Prairieville Township
T 1 N R 10 W
Barry County
Michigan

Section 31
08-12-031-
Scale 1"= 400'

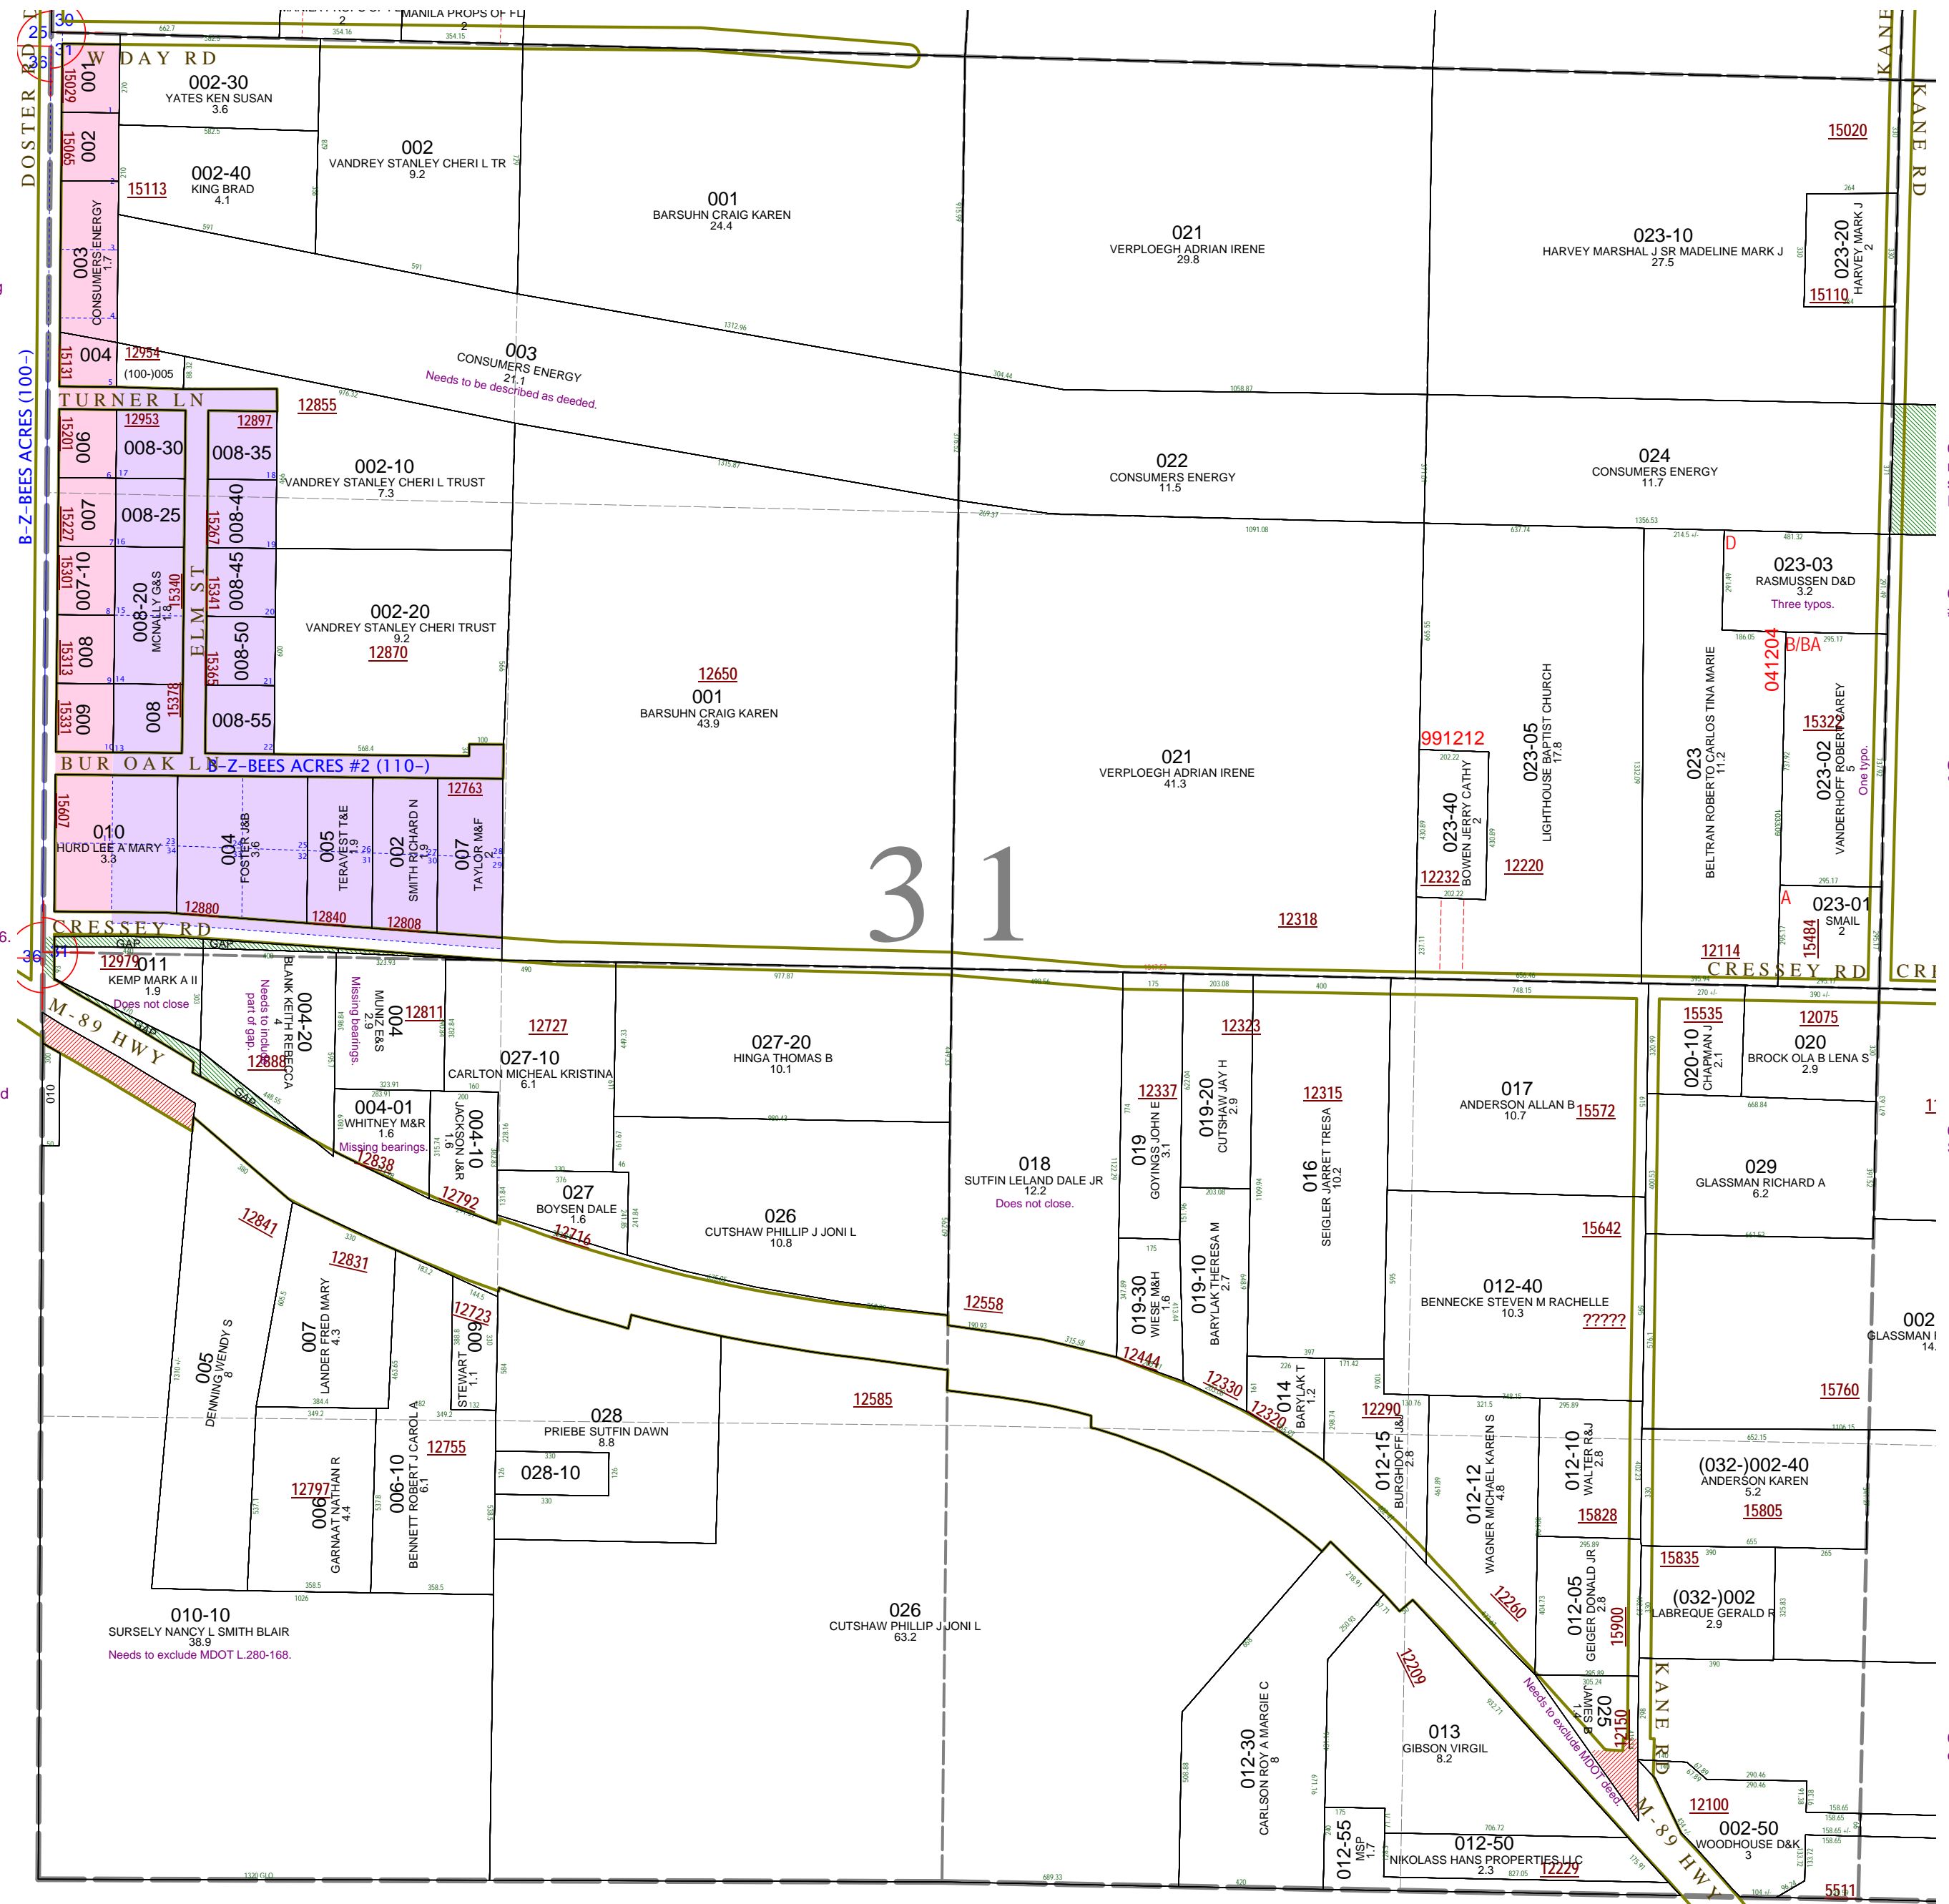
08-12-031-003-00 needs to be described as deeded and has been surveyed for consolidating notice of claim in R#1160446.

08-12-031-022-00 has had its bearings cut off, needs to be described as deeded and has been surveyed for consolidating notice of claim in R#1160446.

08-12-031-023-03 has three typos. See split #041204.

08-12-031-023-02 has a small typo, change "TH 00D 43M 35S E" to "TH N0'43'35"E".

08-12-031-011-00 does not close. See L.651-216.
08-12-031-004-00 needs to be described as surveyed for quit claim R#1093647
GAP owned by William C. & Virginia Russell in L.411-775
08-12-031-004-20 was illegally split by R#1117101 but would include part of that southern gap.
SPLIT from 004-20. Parcel retained by Cutler and not sold to Blank in R#1117101.
08-12-031-004-01 is missing its bearings. See R#1097979.
08-12-031-010-00 has the course bearings rounded off and needs to be described as surveyed in L.1-66.

08-12-031-018-00 does not close in last course. See deed R#1169138.

08-12-031-010-10 needs to exclude parcel deeded to MDOT in L.280-117.

08-12-031-025-00 needs to exclude highway deeded to MDOT in L.280-340.
